This Service Information bulletin supersedes S.I. B51 02 05 **dated December 2006.**

Squeaking Noise From Door Frame Area While Driving

E60, E61 (5 Series)

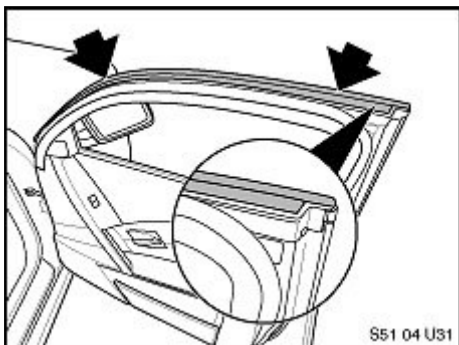
Movement between the flocking material (felt-like material indicated by the arrows) on the upper door seal and the surrounding roof panel may produce squeaking or creaking noises. These noises may be amplified by contamination or cleaner residue on the door opening.

In case of a customer complaint, refer to the procedure outlined below to replace the seals with improved parts and/or apply the specified transparent Teflon tape.

The flocking material was changed in 01/2005 to an improved material with exceptional rigidity, strength, and low moisture absorption.

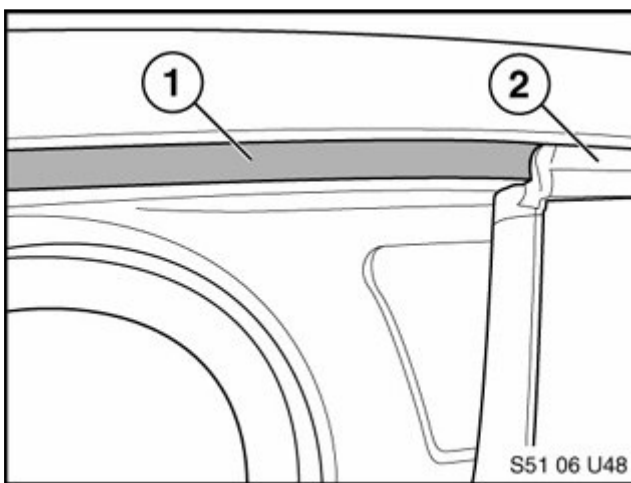
(PN 9 407 798) to the contact area of the flocking material (1) on the body of the vehicle.

The area where the tape should be applied to spans from the middle of the a-pillar to the rear-most point on the rear door opening as indicated by the arrows.

The tape should be applied slowly and very carefully to avoid trapping air bubbles under the tape.

To eliminate visibility of the tape when the door is closed and ensure proper contact with the flocking surface, the upper edge of the tape (1) should line up evenly with the top of the door seal (2) for the entire length of the applied area.

The tape should be applied in its full width (16mm), not be cut down to a narrower width.
